# Coastal Access – Marsland Mouth to Newquay lengths MNQ1, MNQ3 to MNQ5 and MNQ7 to MNQ11

## Representations with Natural England's comments

July 2020

Document A: MCA/MNQ1/R/2/MNQ0975: Revised map MNQ1b

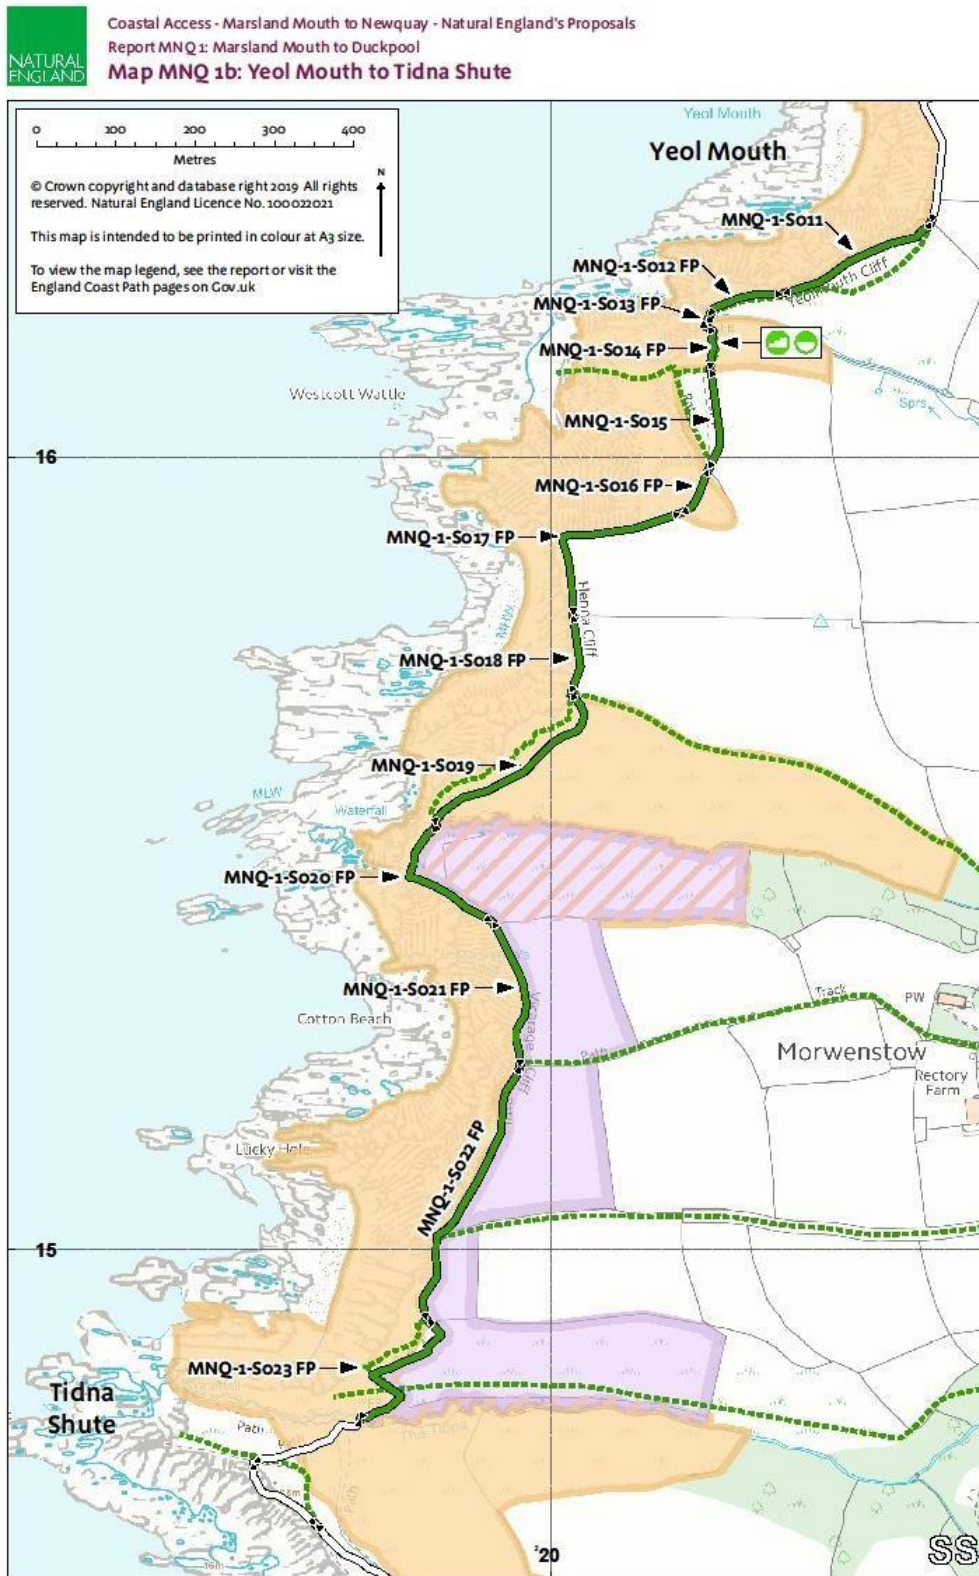
The coast path has recently been moved a little further inland because of cliff fall but the original route, now unstable, is shown on the proposal map.

The route shown following the promontory is unstable and was roped off in 2017. A more direct route over a length of about 40m avoiding the promontory is required.

The first point is a reference to section MNQ-1-S023 of the proposed route shown on map MNQ1b. We agree it is shown incorrectly on the report map and our proposals are intended to follow the currently walked line of the South West Coast Path which, after a recent realignment, is now slightly further inland. We have amended our dataset to correct this mapping error and a revised map is shown as document A in section 5 below. At the small scale of the report map it is difficult to see the revision. We ask that the Secretary of State notes this mapping error and approves the proposals in the report with the correction shown on the revised map MNQ1b in section 5 below. We have shown the revised map to the land owner who has confirmed they are content for us to propose this minor clarification.

We agree that the mapped route shown on map MNQ1c (route section MNQ-1-SO26) is incorrect and doesn't take into account the previously realigned path slightly inland which has been the currently walked route of the South West Coast Path (SWCP) for the last 3 years. Our proposals are to follow the SWCP along this section of coast. We have amended our dataset to correct this mapping error and a revised map is shown as document B in section 5 below. At the small scale of the report map it is difficult to see the revision. We ask that the Secretary of State notes this mapping error and approves the proposals in the report with the route clarification shown on the revised map MNQ1c in section 5 below.

Document A: MCA/MNQ3/R/3/MNQ0973 & MCA/MNQ3/R/6/MNQ1031 - shows the contours of the ground landward of the road section MNQ-3-S011 between points A and B.

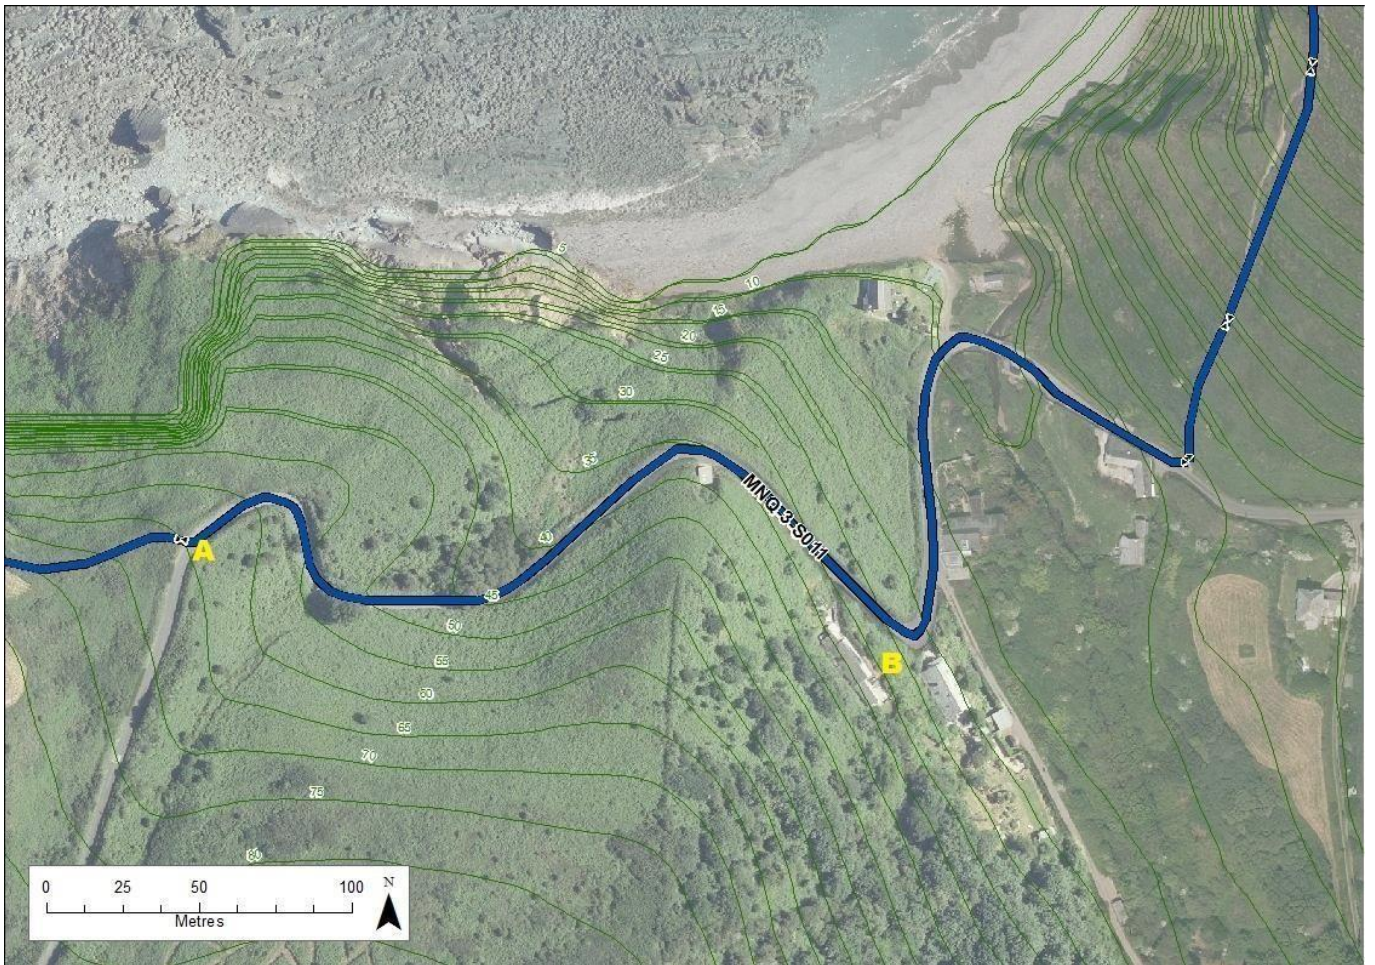
<b>Route section(s) specific to this representation:</b>	Map MNQ3b; MNQ-3-S011
<b>Other reports within stretch to which this representation also relates:</b>	N/A
<b>Representation in full</b>	
<p>Millook: The current route uses a road here. This is steep and winding and carries tourist traffic in summer. It is therefore not very suitable for the trail for environmental and safety reasons. It is noted that there are concerns that the ground to seaward of the road would not be suitable for the trail alignment because of its instability. An alignment landward has been dismissed because of the steep gradient. This steepness is accepted, but given that a great deal of the route dealt with under the MNQ Report is extremely steep, it is suggested that provision of a steep route here would not be unacceptable in this area. A route landward is therefore urged as a better option than use of the road.</p>

<b>Natural England's comments</b>	
<p>We were initially hopeful that an alignment could be found to take walkers off the 320 metre section of road. However, as acknowledged in the representation and table 3.3.4 of report MNQ3, the land seaward of the road is prone to subsidence and so is unsuitable for creating a new route on. The ground landward of the road is very steep and undulating; any route across this area would introduce more ascent/descent to an already physically challenging coast path walk around Millook (see document A in section 5 below). In order to implement such a route it would be necessary to excavate a path and install hundreds of steps. Our view is that the costs of doing so outweigh the potential public benefit; it is proposed that walkers continue to follow the existing South West Coast Path along the road which gently ascends/descends the gradient. The Access Authority have confirmed that traffic on the road moves slowly because of its twisting nature and suggest there is a low risk to walkers.</p>

Document C: MCA/MNQ3/R/7/MNQ0975 Route section MNQ-3-S001. The line of the proposed ECP along the road and grass verge is indicated by red dots. The yellow line encloses the area used by the outdoor activity centre; camping areas and private paths used by their residents are evident.

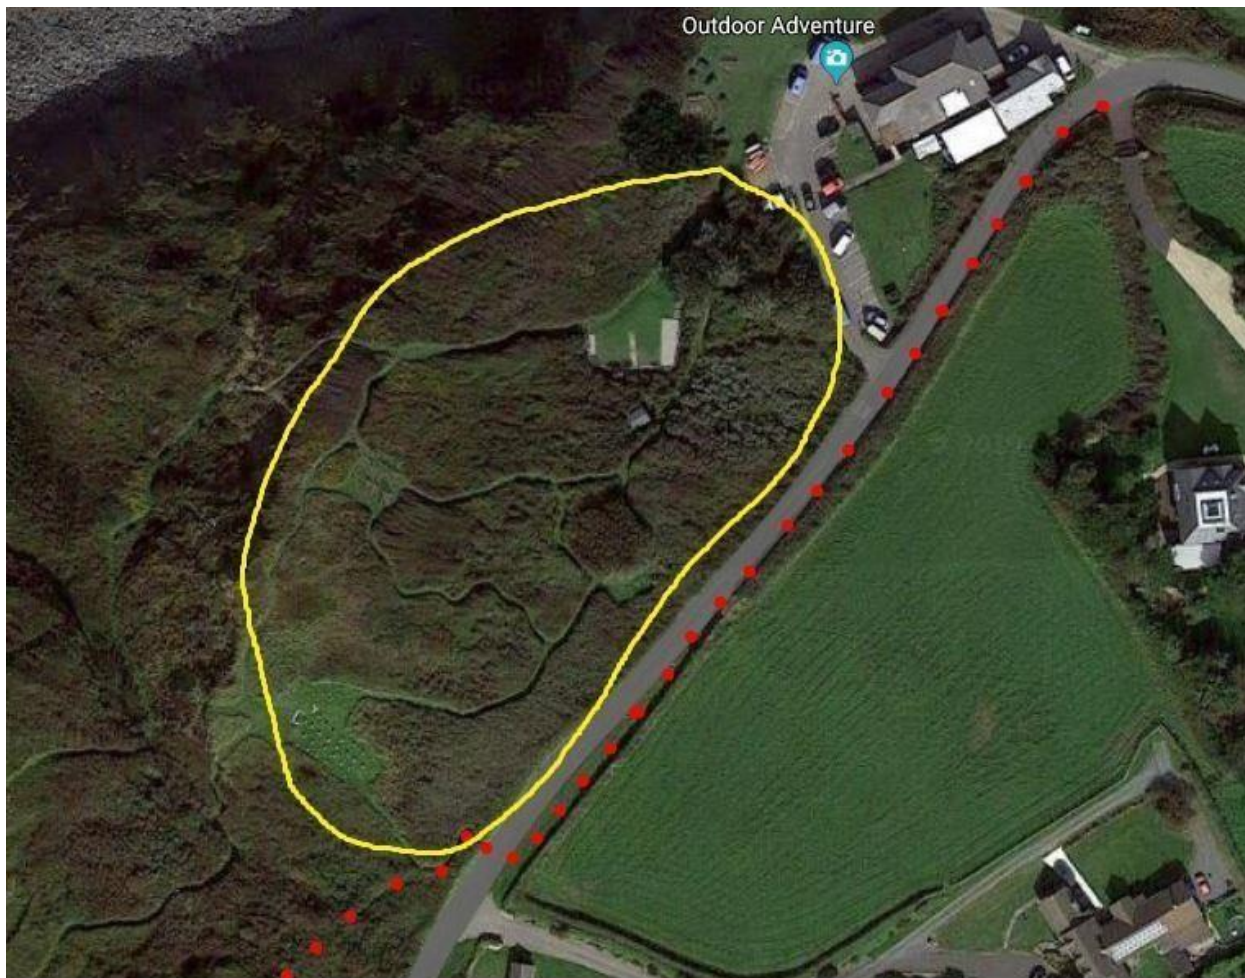
We agree with the comment in the representation about the road section along MNQ-3-S001 being unpleasant to walk and so we explored the possibility of taking the route off the road towards the seaward cliffs. However, there were two reasons why we concluded this to be inappropriate:

Whilst we appreciate the desire to find an off-road alternative route along MNQ-3-S001, for the reasons outlined above this was not possible. However, there is a wide grass verge adjacent to some of the road section which is currently used by walkers (see document D in section 5 below). The road is straight with good sight-lines for drivers/walkers so the Access Authority have confirmed that in their view the proposed route, following the existing South West Coast Path, doesn't pose an unacceptable risk for walkers.

# Document E: MCA/MNQ3/R/8/MNQ0975 revised map MNQ3c

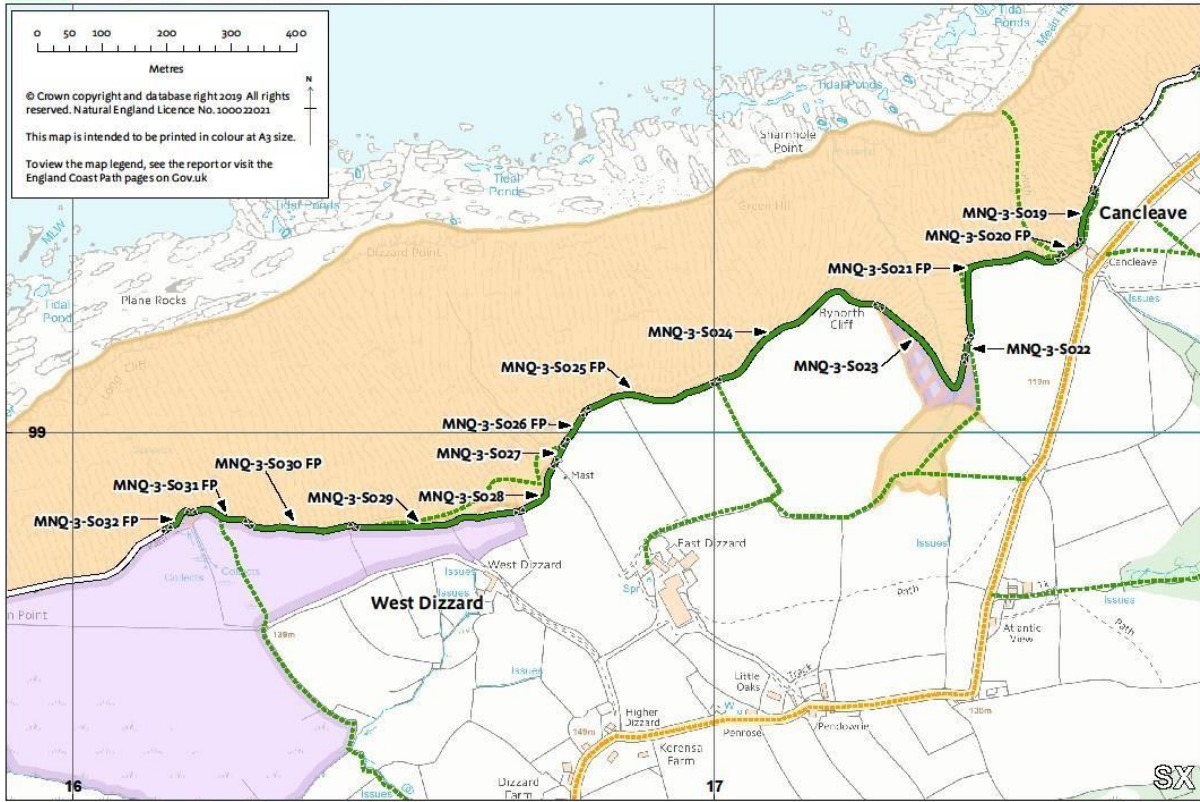
As highlighted in the representation, the full extent of the boundary of the landward coastal margin (pink shading) was not shown on the report maps MNQ3c and MNQ3d. We have prepared revised maps which show its full extent and these are included in section 5 of this document. The relevant land is owned by the National Trust, which gave its agreement for it to form part of the landward coastal margin before the report was published, having consulted with the farm tenant. Accordingly we ask that the Secretary of State notes the omission in the original report. We have published a revised version of the report with the amended maps and a note to explain the amendment.

**Document A: MCA/MNQ4/R/2/MNQ0973** - Map shows the proposed route of ECP, the existing optional inland route and the section of steep steps referred to in the representation

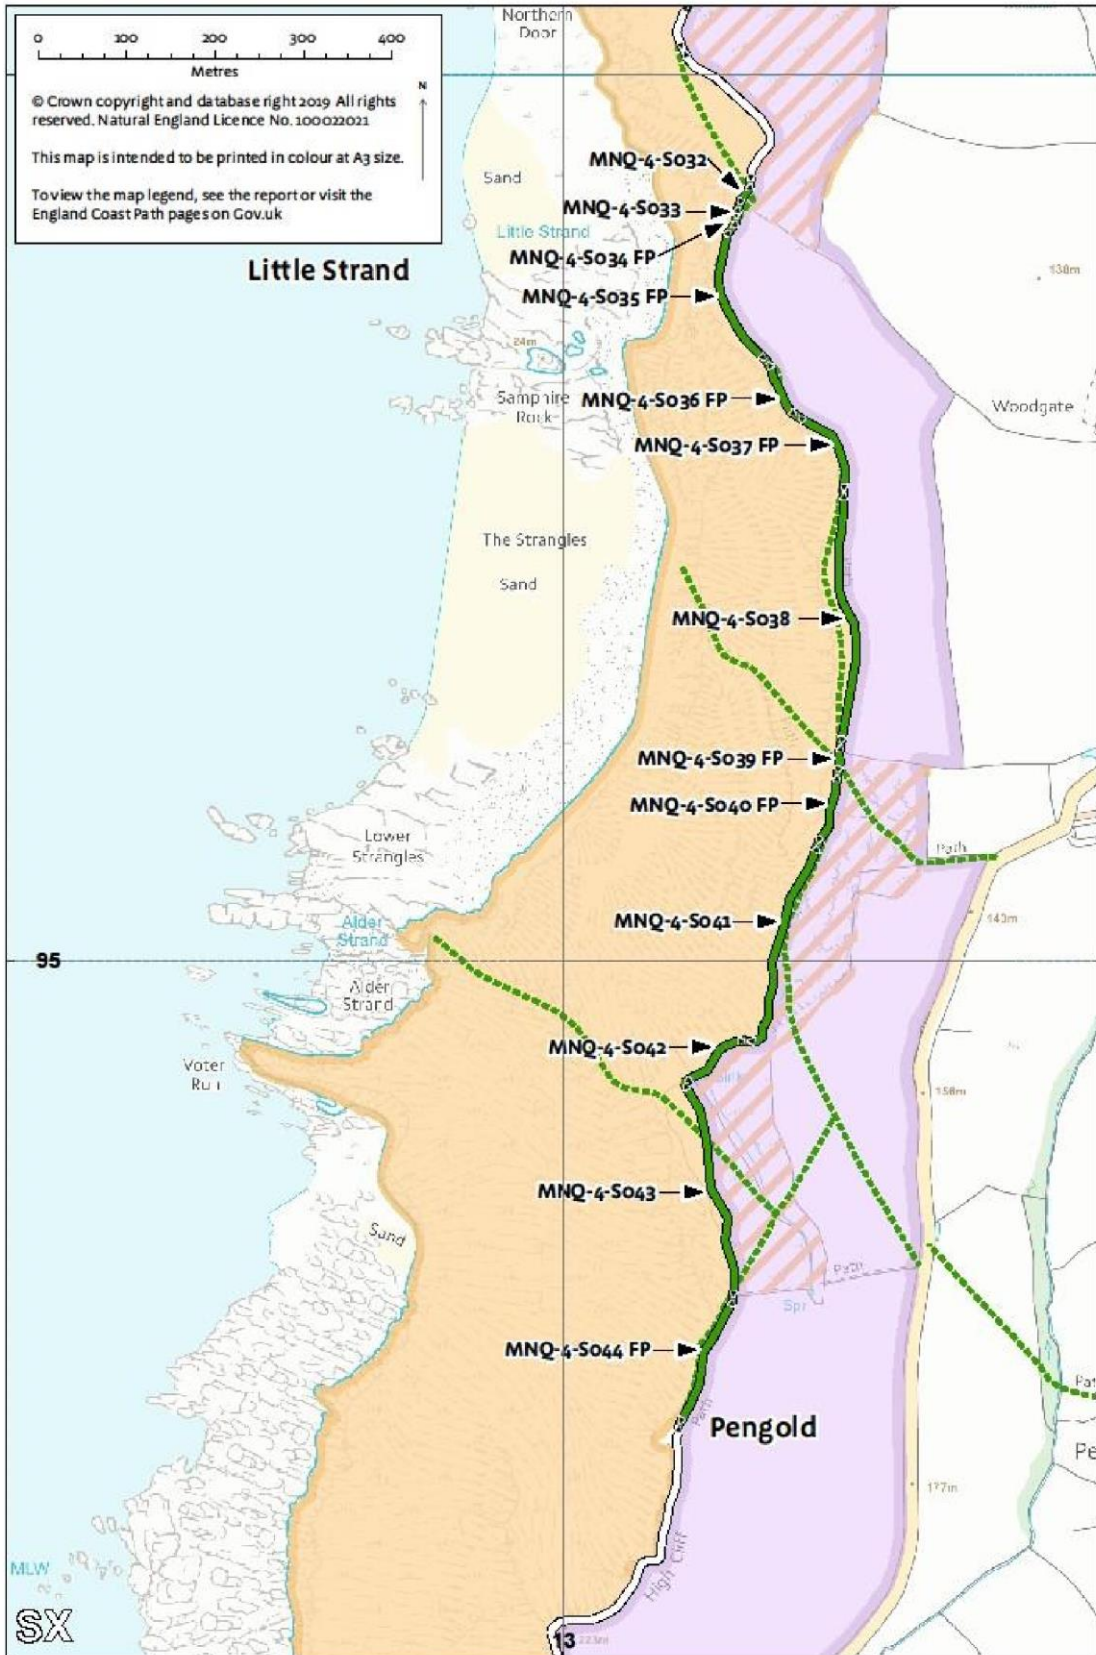
<b>Representation number:</b>	MCA/MNQ4/R/2/MNQ0973
<b>Organisation/ person making representation:</b>	Cornwall Countryside Access Forum
<b>Route section(s) specific to this representation:</b>	Map MNQ4e; MNQ-4-S069 and MNQ-4-S070
<b>Other reports within stretch to which this representation also relates:</b>	N/A
<b>Representation in full</b>	
Fire Beacon Point: There is an abrupt change in the level of the path which requires use of a steep, rocky and exposed flight of steps. Use of the steps can be particularly daunting when descending. While there is a permissive inland alternative this means omitting a particularly fine length of path on Beeny Cliff. It is suggested that improvements to the steps are required to enable safer use of the steps, especially when descending.	
<b>Natural England's comments</b>	
The route descending from Fire Beacon Point using a long flight of steps seems very dramatic because the user feels exposed to the elements next to rocky, steep, cliffs. However, the National Trust (landowners) and the Access Authority do not consider this route to be dangerous or in need of further improvement to the steps. For those walkers daunted by the steep descent, or visiting during wet and windy conditions, there is already a well-used and signposted alternative route which goes slightly inland and avoids the steps; this provides equally good sea views for the walker (see document A in section 5 below).

Document C: MCA/MNQ4/R/5/MNQ0975 – Revised map MNQ4c

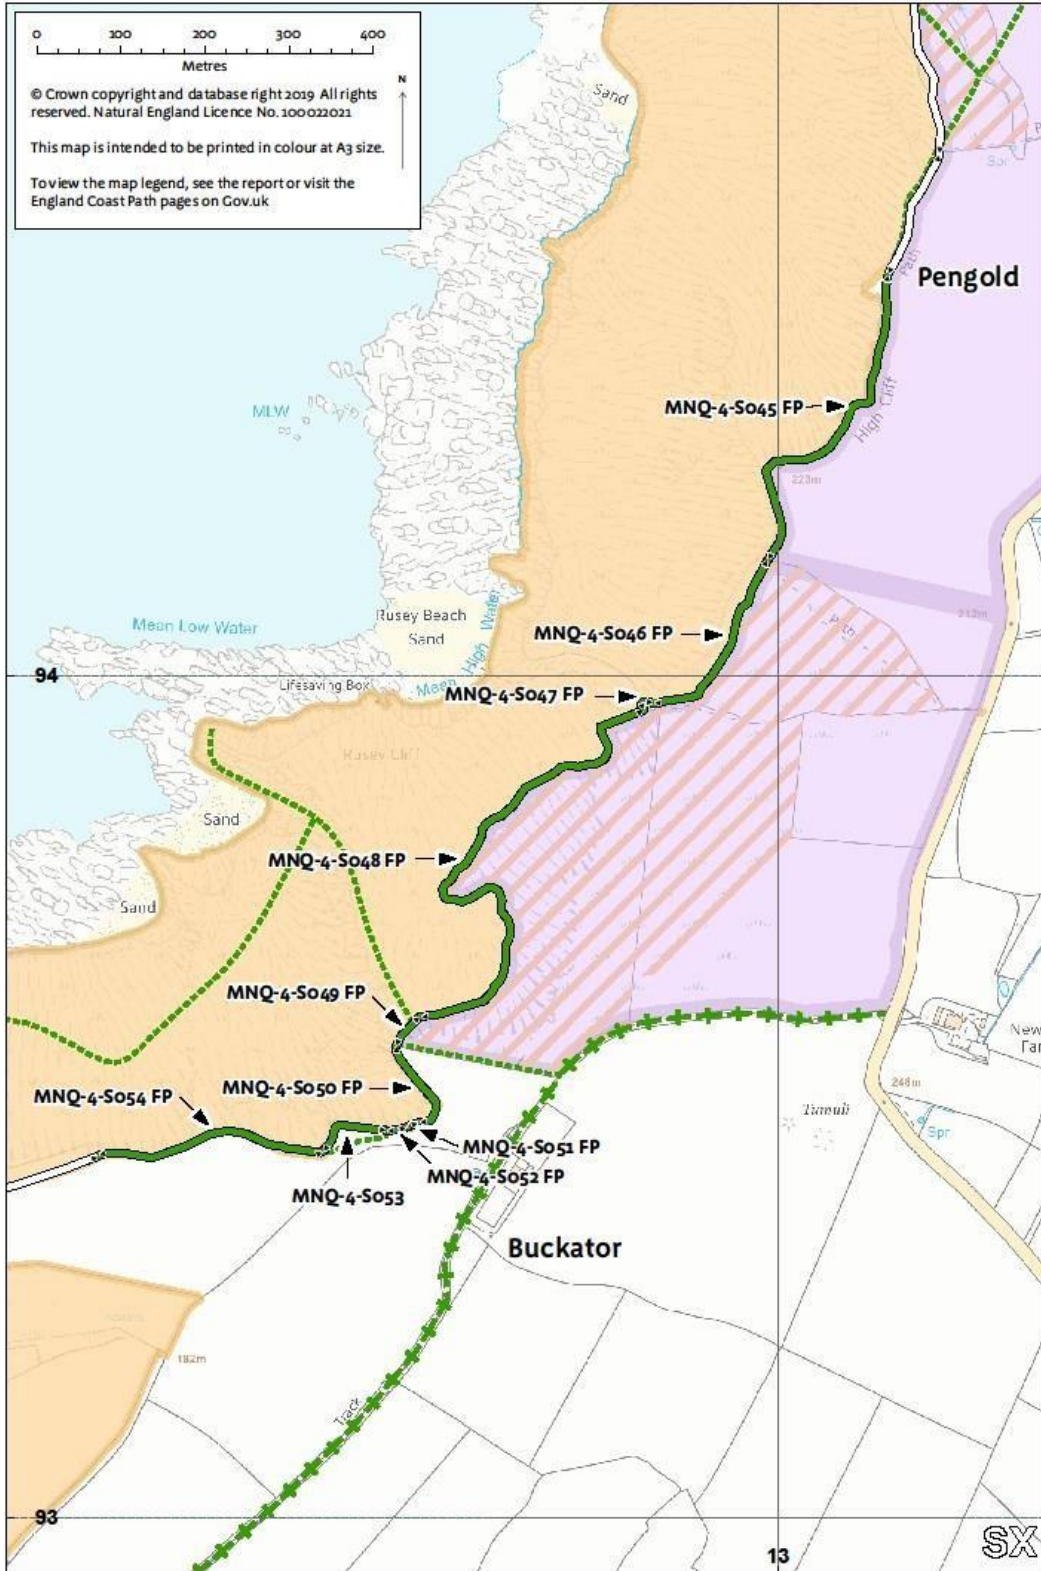
<b>Natural England's comments</b>	
We welcome the positive engagement from the Ramblers' Association during the development of our proposals and the supportive comment in its representation. As highlighted in the representation, the full extent of the boundary of the landward coastal margin (pink shading) was not shown on the report maps MNQ4b and MNQ4c. We have prepared revised maps which show its full extent and these are included in section 5 of this document. The relevant land is owned by the National Trust, which gave its agreement for it to form part of the landward coastal margin before the report was published, having consulted with the farm tenant. Accordingly we The Secretary of State ask that the Secretary of State notes the omission in the original report. We have published a revised version of the report with the amended maps and a note to explain the amendment.	
<b>Relevant appended documents (see section 5):</b>
